Comment Letter O3: Advocates for the Environment, 9 pages

Re: Comments on Draft Environmental Impact Report for Harvest Landing Retail Center &
Business Park Project, SCH No. 2024080337

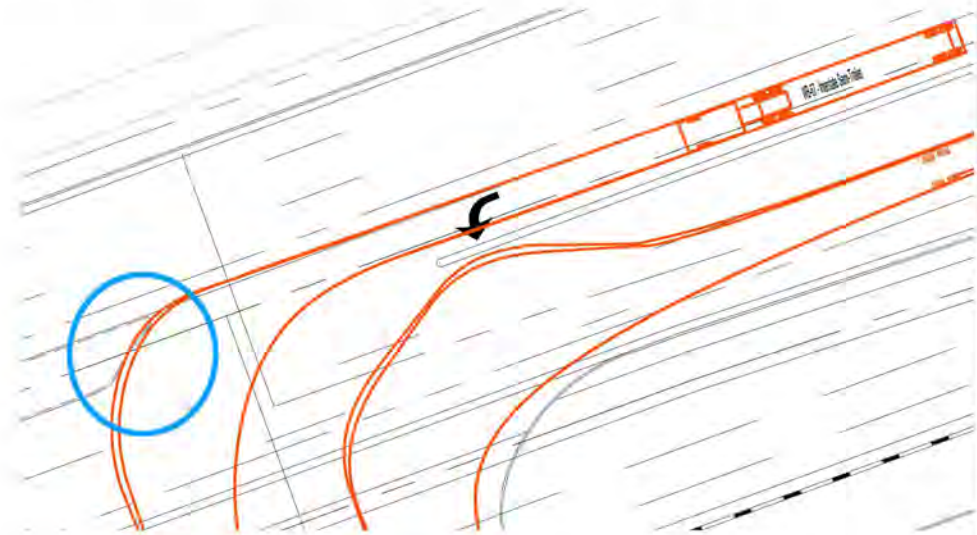
The EIR has not adequately analyzed the project’s potential to substantially increase hazards due to a geometric design feature (e.g., sharp curves or dangerous intersections) or incompatible uses; or the project’s potential to result in inadequate emergency access. Appendix F – Truck Turning Templates and Driveway Spacing Measurements within Appendix R - TIA depicts several areas

Comment O4.22: This comment states that the Draft EIR does not adequately analyze the Project's potential impacts regarding hazards due to a geometric design feature. The comment explains that there are areas of overlap between truck movements for the truck entering the site via Frontage Road at Building 2.

Response O4.22: This comment does not provide any substantial evidence that the Project would result in a significant environmental impact. The Project would include five truck driveways along Frontage Road and installation of a truck-only Private Drive A for the industrial portion of the Phase 1 development. The commercial component of the Phase 1 development would require one truck driveway on Orange Avenue, one truck driveway on Harvest Landing Way, and one truck driveway on Barrett Avenue. Lastly, while potential development plans and internal circulation within the Phase 2 area is unknown at this time, the City of Perris will be conditioning future development of the area to solely provide truck driveways for Phase 2 developments on Orange Avenue and Frontage Road in order to avoid the sensitive receptors located along Indian Avenue (with Val Verde Elementary school operational along Indian Avenue) and Barrett Avenue.

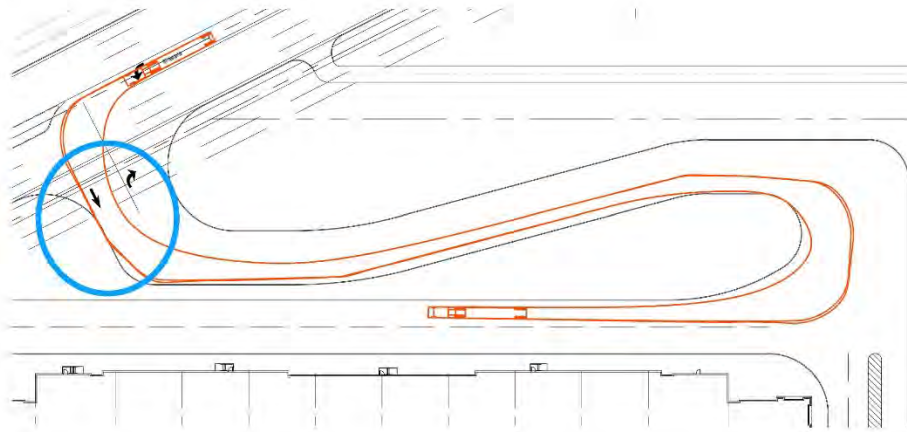
The same is true for the truck entering the site via Frontage Road at Building 6, which will overlap on the internal curb, indicating there is not suitable available space to accommodate truck maneuvering. This exhibit also does not depict two trucks simultaneously entering and exiting site and there does not appear to be enough maneuvering space for two trucks given that there is not enough area for a single truck without overlapping on the internal curb. The geometric design of the circulation system and project site will substantially increase hazards and a significant and unavoidable impact exists, which must be disclosed in a revised EIR.

Comment O4.23: This comment states that the Draft EIR does not adequately analyze the Project's potential impacts regarding hazards due to a geometric design feature. The comment explains that there are areas of overlap between truck movements for the truck entering the site via Frontage Road at Building 6.

Response O4.23: Please refer to Response O4.22.

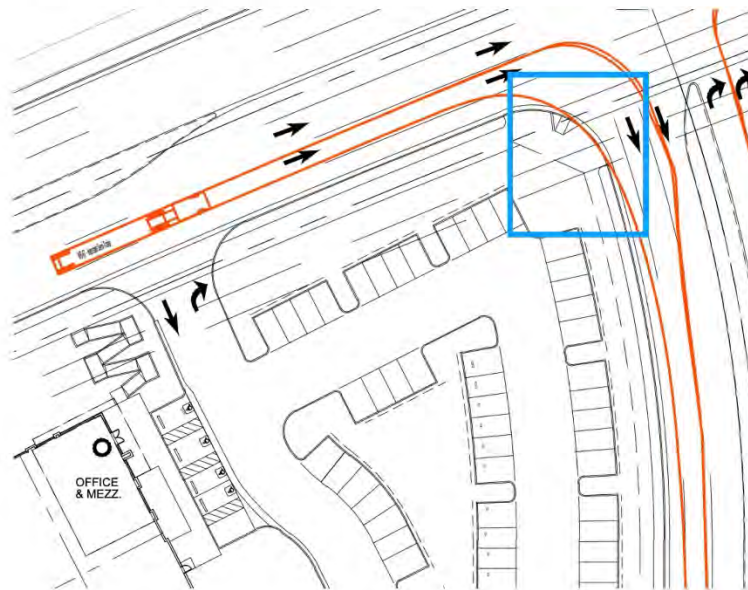
A similar issue exists for the truck entering the site via Frontage Road at Private Drive A between Buildings 2 and 3. This truck will also overlap on the curb, indicating there is not suitable available space to accommodate truck maneuvering. The geometric design of the circulation system and project site will substantially increase hazards and a significant and unavoidable impact exists, which must be disclosed in a revised EIR.

Comment O4.24: This comment states that the Draft EIR does not adequately analyze the Projects potential impacts regarding hazards due to a geometric design feature. The comment explains that there are areas of overlap between truck movements for the truck entering the site via Frontage Road at Private Drive A between Buildings 2 and 3.

Response O4.24: Please refer to Response O4.22.

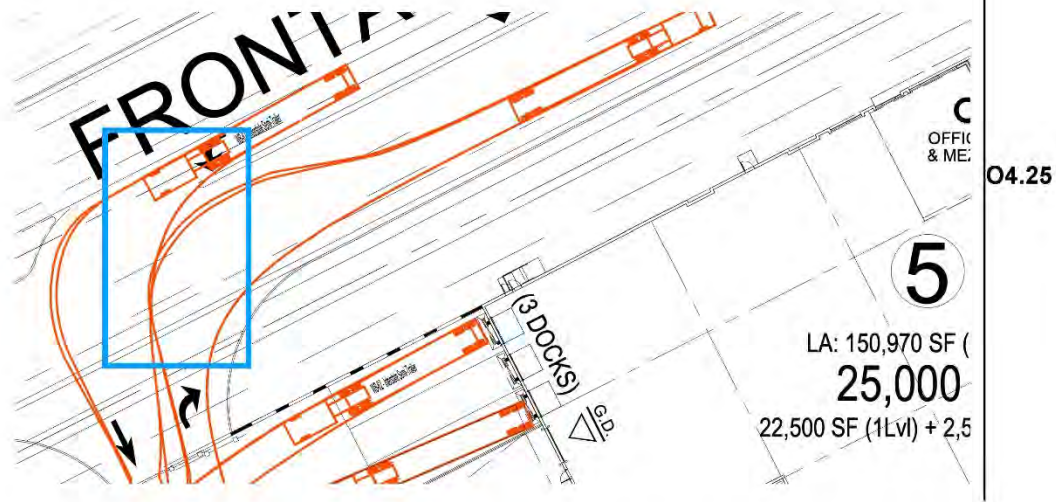
It is particularly notable that the trucks accessing the site via Frontage Road at Building 5 will collide on Frontage Road. The geometric design of the circulation system and project site will substantially increase hazards and a significant and unavoidable impact exists, which must be disclosed in a revised EIR.

Comment O4.25: This comment states that the Draft EIR does not adequately analyze the Projects potential impacts regarding hazards due to a geometric design feature. The comment explains that there are areas of overlap between truck movements for the truck entering the site via Frontage Road at Building 5.

Response O4.25: Please refer to Response O4.22.

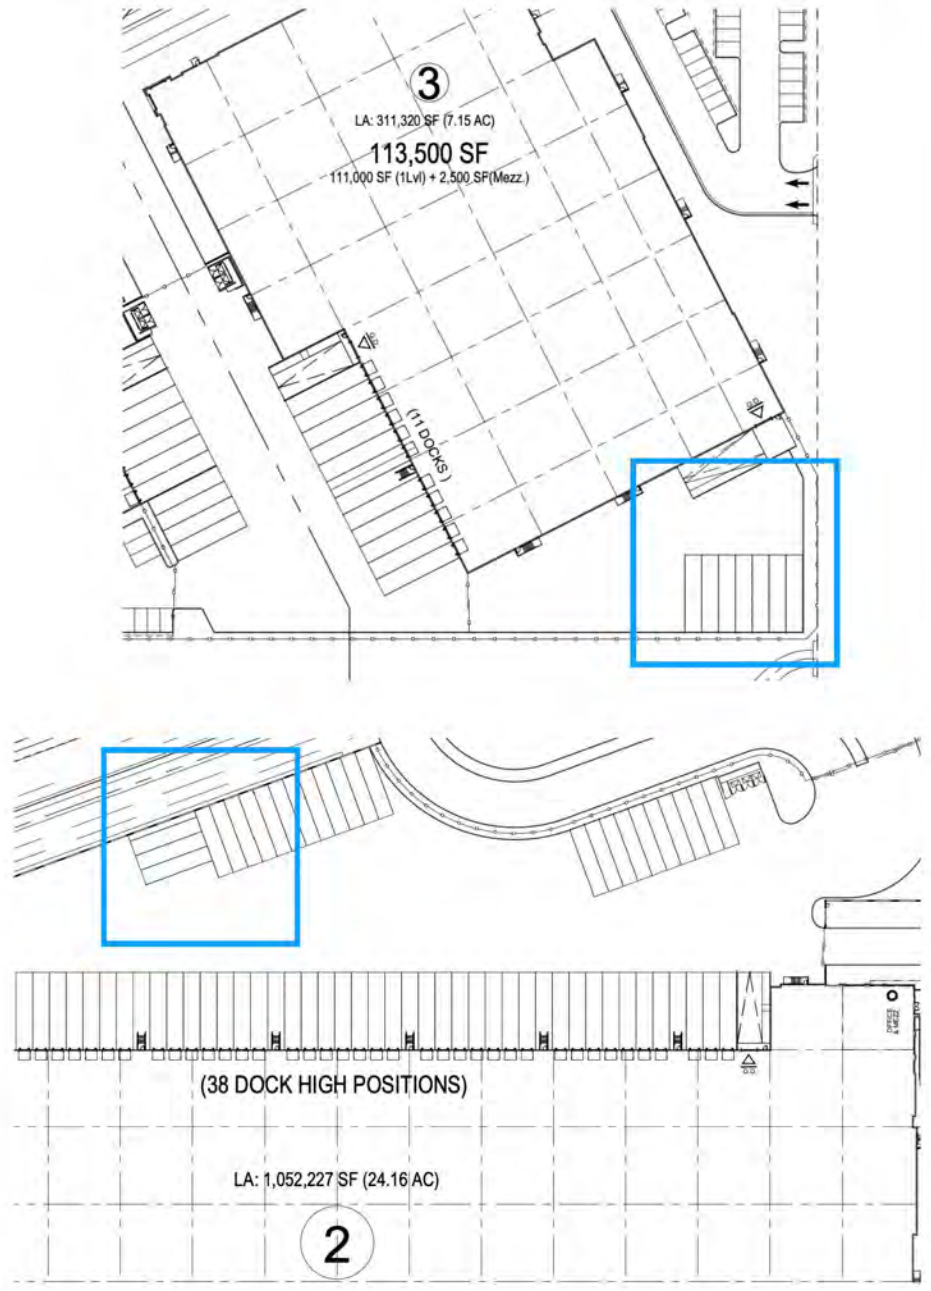
Additionally, trucks accessing the internal truck/trailer loading dock court between Buildings 3 and 4 do not have adequate internal maneuvering space. As shown below, a single truck backing into a loading dock space requires the entire loading dock area to maneuver into the space. There is no other maneuvering area available, meaning that other trucks must queue and wait for the area to clear in order to proceed. Increased queuing results in increased idling (and associated emissions) will require increased internal queuing area in order to avoid queuing on Frontage Road. The geometric design of the circulation system and project site will substantially increase hazards and a significant and unavoidable impact exists, which must be disclosed in a revised EIR.

Comment O4.26: This comment states that the Draft EIR does not adequately analyze the Project's potential impacts regarding hazards due to a geometric design feature. The comment explains that there are areas of overlap between truck movements for the trucks accessing the internal truck/trailer loading dock court between Buildings 3 and 4. Additionally, the comment states that there are no exhibits adequately depicting the onsite turning radius available for trucks maneuvering throughout the parking areas of the site as well as exhibits depicting emergency vehicle access and maneuvering. The comment concludes in stating that the Draft EIR defers analysis by stating that the Riverside County Fire Department would review plans without listing any requirements.

Response O4.26: As shown in Appendix R of the Draft EIR (Table 4.1b: Project Trip Generation), buildings 3, 4 and 5 would have a truck trip generation of 6 truck trips (3 total trucks) during the AM peak hour and 5 truck trips (3 total trucks) during the PM peak hour. These trips are for all three buildings, resulting in a maximum of 1 to 2 trucks per hour entering or leaving each building. Because of the very low volume of trucks entering and departing, delays would be minimal. It is likely that trucks would not be entering or leaving at the same time. Therefore, additional emissions or queuing due to conflicts between trucks would be negligible and not measurable. Therefore, the results of the analysis would remain unchanged.

Figure 1. Existing, approved, and under review warehouses along the 215/60 corridor centered on the project. Screenshot from Warehouse CITY v1.23.

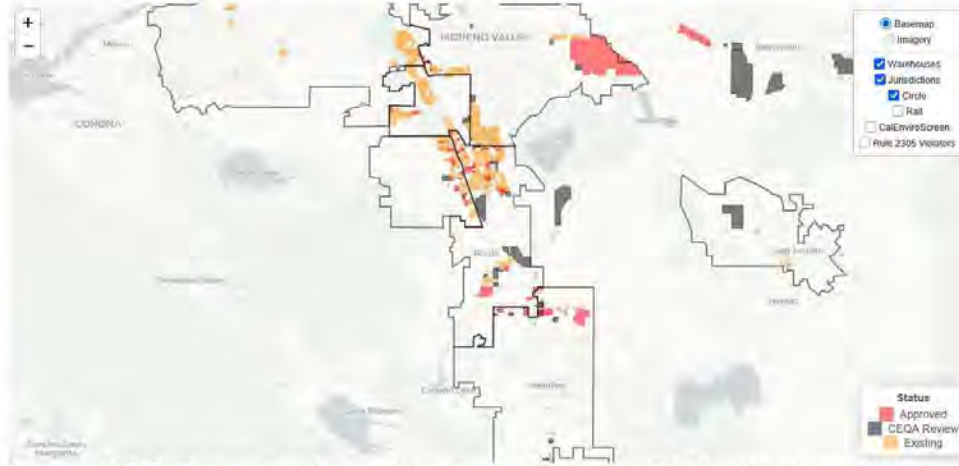
When the full list of local and regionally important projects is considered, the cumulative impacts will be seen. **Figure 1** shows a reasonable cumulative impacts map for warehouses. **Figure 2** shows the cumulative area per resident by municipality (> 10,000 residents). Perris is currently third and on its way to overtake Ontario. And the most burdened community is next door in Mead Valley. Note that March JPA is not included but has another 20M square feet of warehouses for a minimal population.
